PLC Stamp mini 2 Errata

in-tech smart charging GmbH

August 6, 2020

This document details all known errata for PLC Stamp mini 2.

Figure 1: PLC Stamp mini 2 assembly top drawing

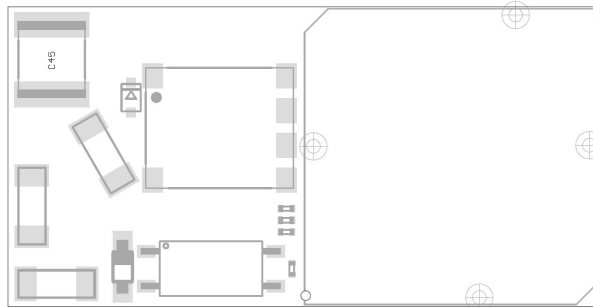
The capacitance value (4700 pF) of the coupling capacitor is too large.

When using the modules in a PEV/EVSE scenario the IEC 61851-1 CP PWM requirements for signal rise and fall times cannot be met.

Replace the capacitor C45 in Figure 1. Use a capacitor with following properties:

- Capacitance: 1000 pF
- Voltage: ≥ 50 V
- Package/Case: 2220 (5650 metric)
